ZOSTRICH GEOTECHNICAL

RE: REVIEW OF NANISIVIK MINE OPENINGS CLOSURE PLAN (JANUARY 27, 2005)

PROJECT: NANISIVIK ROCK MECHANICS REVIEW - III

From Figure 24, Oceanview pit highwall

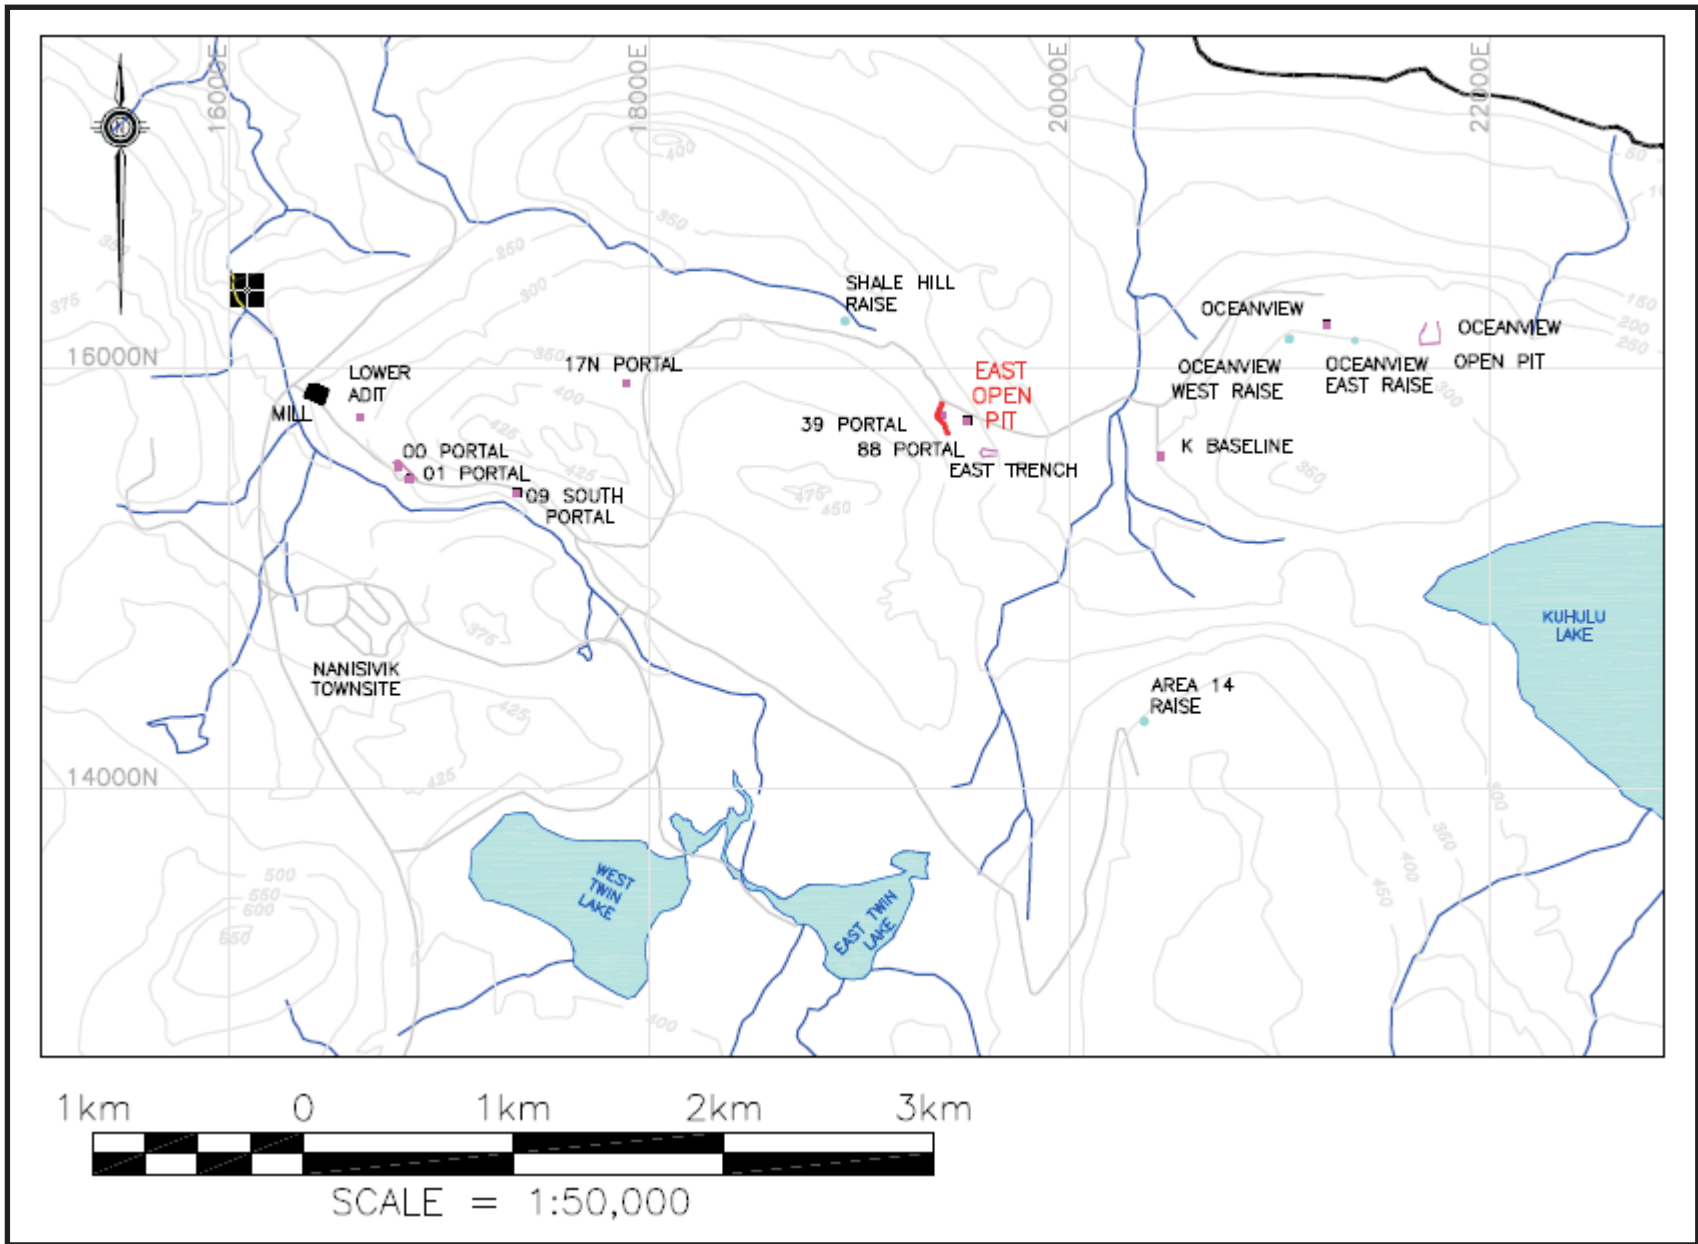
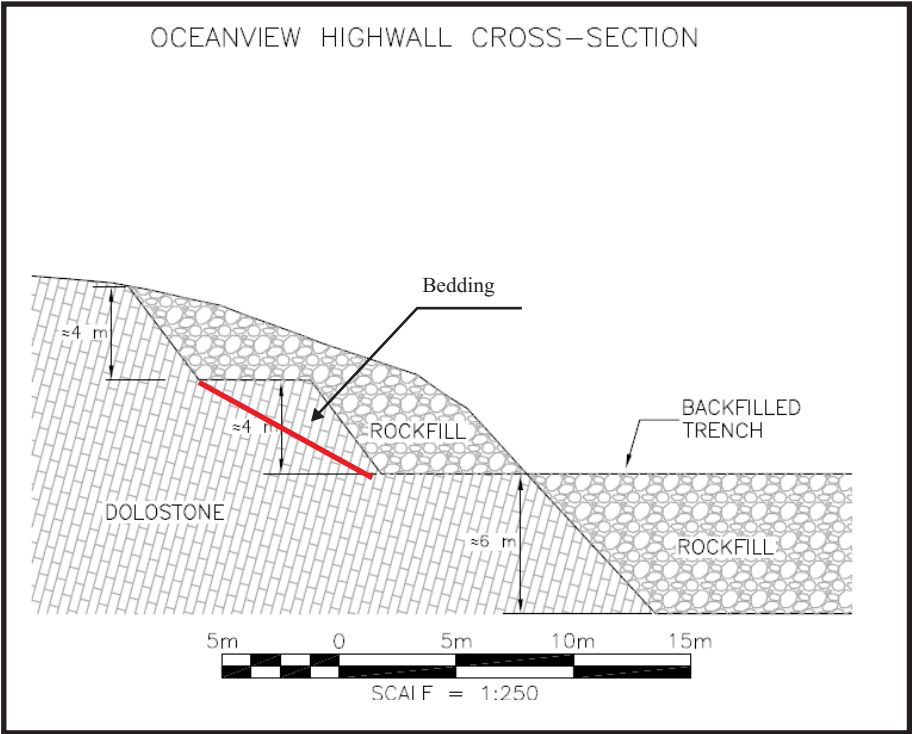
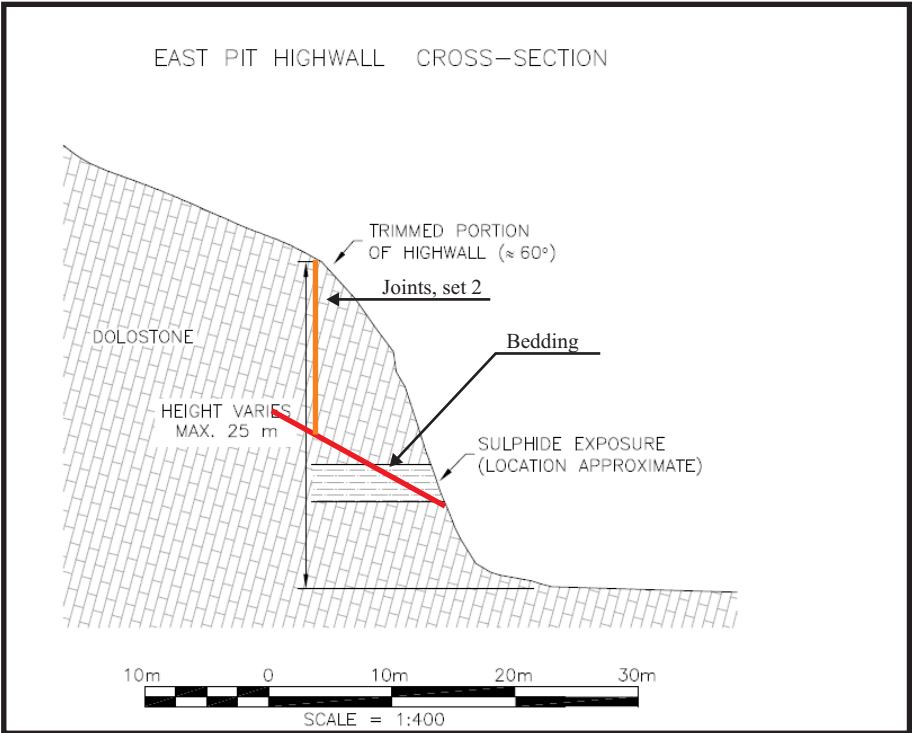
While this is a very shallow pit, as can be seen in Figure A, a potential structural failure geometry may exist in the benches. In addition, there is a lack of stability analyses addressing the stability of these slopes, including pore water pressure, ice, etc. This is a very minor wall. However, for completeness sake, the work should be conducted in a proper engineering manner. In other words: material properties should be listed for design purposes, design assumptions listed (including failure modes), and analytical methods and any computer codes utilized for analysis should be denoted.

Oceanview:
Has the stability of the rock fil, given the shown profile, been analyzed, including pore pressure conditions present during melt. Has the potential complex failure geometry of bedding joints combined with a circular type failure been analyzed?

East pit area:
Have the joints in the bench shown on the schematic section been mapped? If the joint pattern follows that obtained from the West pit area, then bedding joints may create a potential long term failure geometry (frost action driven) as shown. Has this been analyzed and taken into account?

Both geometries assume that the pit walls are north to northeast facing. The lack of a detailed map view and section locations on plan makes this assumption necessary.

From Figure 28, 39 portal area (east adit area) field mapping

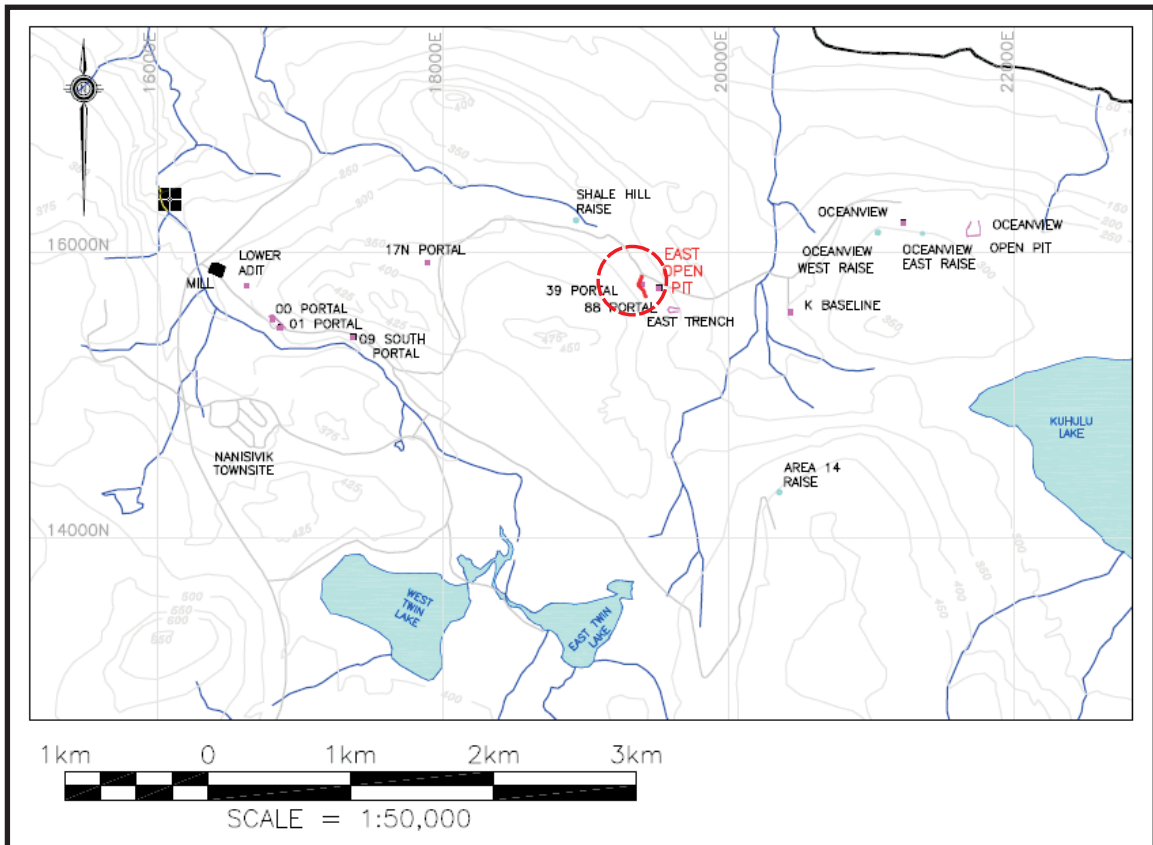
Here, a 25m high wall, apparently excavated as a single bench, is shown in section. This apparently faces somewhat to the northeast. If so, and if the structural mapping as obtained from Figure 28 is correct, then the bedding will be dipping out of the face in plane shear mode. Sub-vertical jointing would function as side and back releases for a kinematically viable failure. However, this is nowhere noted in the report nor addressed for closure. Does this jointing exist in this area? If so, does the sulphide zone shown on the highwall parallel bedding? What will occur if and when the sulphide decomposes, or will it? Will a step path be created by bedding in combination with the sub-vertical joints working back up the slope, driven by frost and water action? What engineering has been conducted to reach the design presented?

From Figure 29, Plan detail of Horseshoe blast area

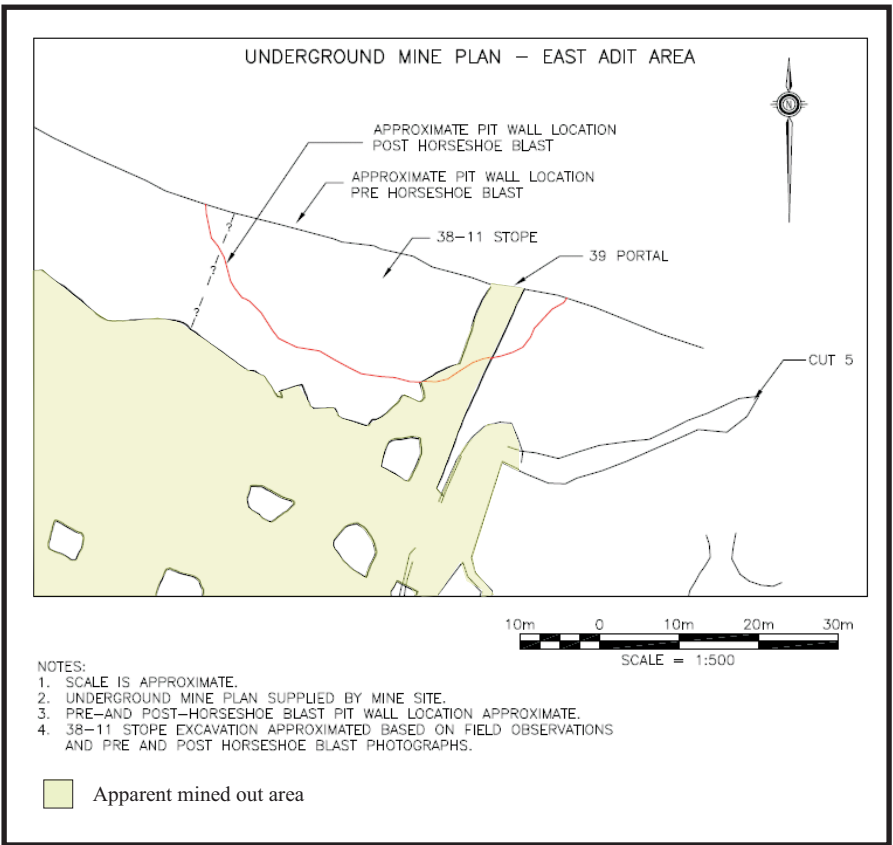
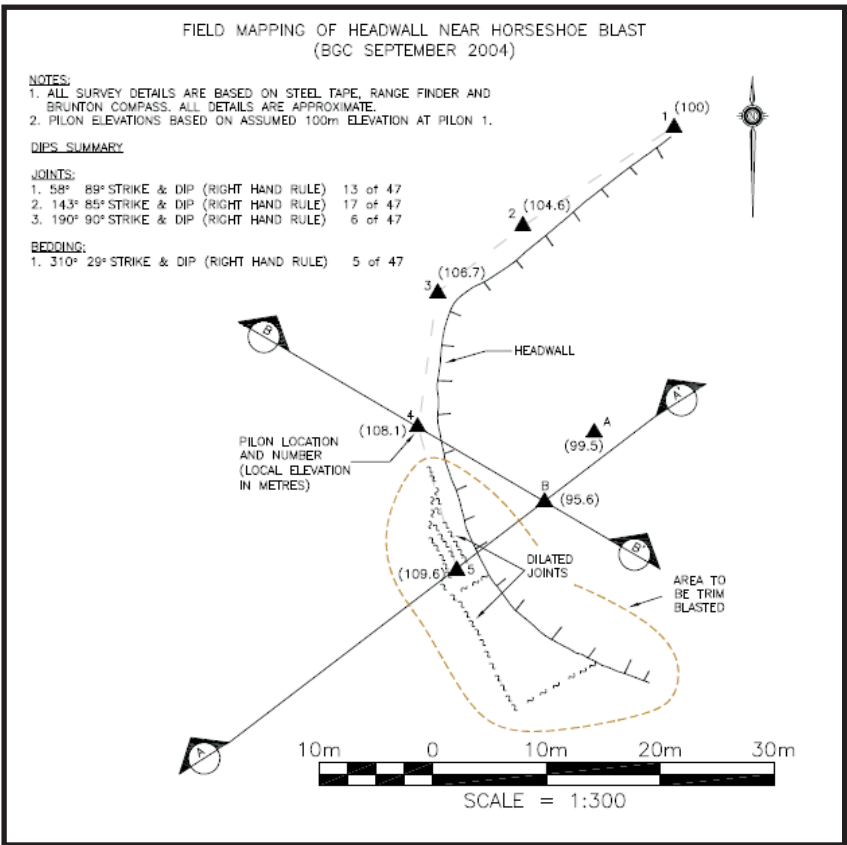
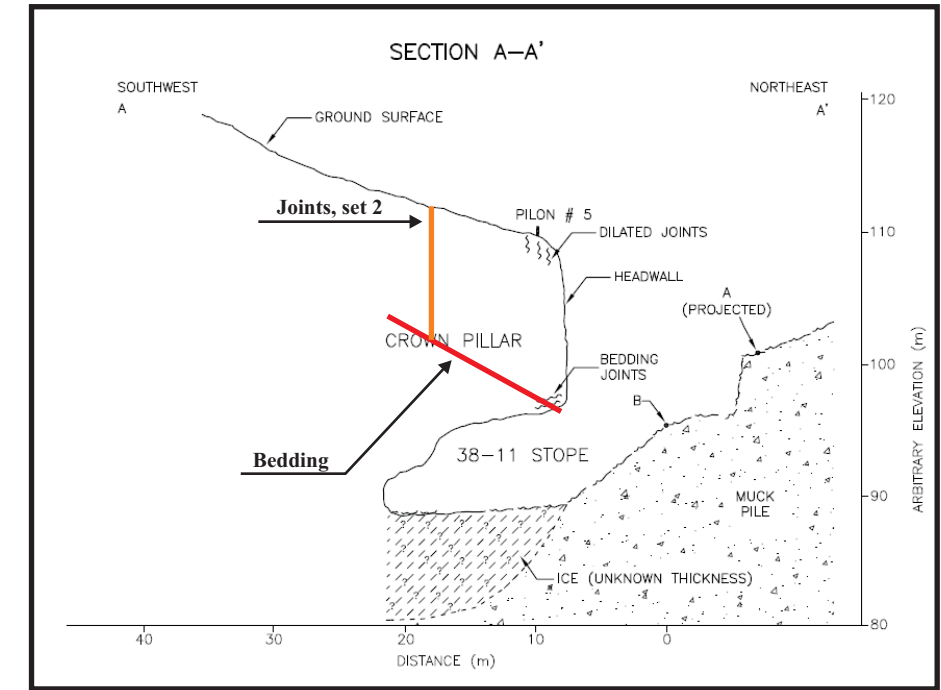
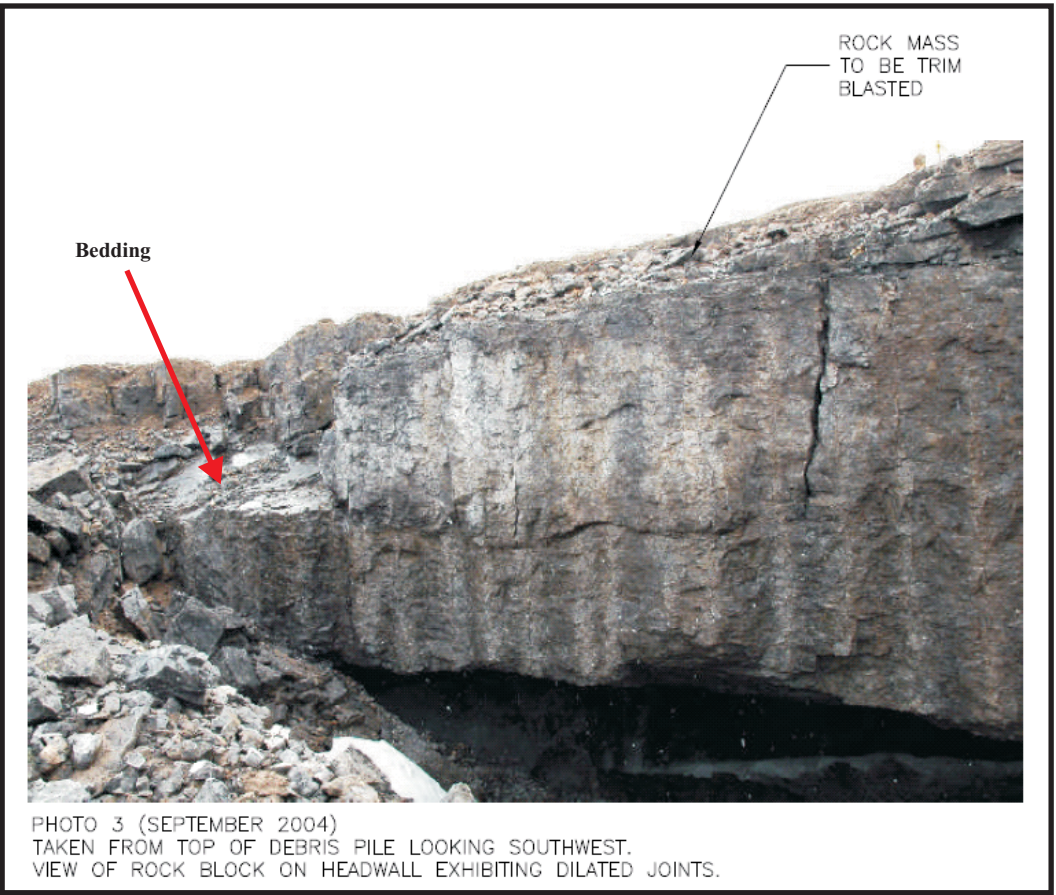
As can be seen in Figure B, the underground workings have apparently been daylighted under the highwall of the East pit (?). The exact geometry of the situation is difficult to discern from the mine plan (Figure B) and the limited number of sections provided. In fact, if one interprets the mine plan as shown on the upper center diagram, Figure B, then the Horseshoe blast did not even daylight the mined out area. However, photographs and descriptions elsewhere indicate that the underground workings were daylighted. Thus, a key question remaining is what is the exact geometry of the situation, including the remaining cover, included rock support, and geologic structure, both major and minor, in the area?

In addition, as is obvious from the photographs, a portion of the face is in plane shear on bedding joints. Whether this is blast related is irrelevant at this point, as the geometry obviously exists. How has this been addressed for closure design?

First, in the center diagram above, the mined out area does not appear to daylight in the pit. Yet, the photos and sections clearly show a daylighting stope.

A detailed map is necessary, showing the amount of cantilevered, undercut rock remaining, as well as multiple sections through the area. No stability analysis has been conducted. This is required.

The visible failure mode in the photograph appears to be a plane shear on bedding with a side and back releases by the cross joint sets (see joint attitudes numerically in upper right, sectionally to left). This is also consistent with the area in failure shown in the upper left detail map. The northernmost section of the failure area has limited freedom of motion, potentially restricting failure of this sort.

In a situation such as this, with overhanging rock, viable kinematic failure mechanisms, frost and water action potentially driving such mechanisms, blast damage, etc, a detailed engineering stability analysis is warranted, as is a specific detailed monitoring plan. Visual assessment is insufficient.

A complete engineering analysis is required here prior to determining remediation measures. This has not been conducted. As such, any remedial works proposed at this stage are premature and not verifiable.
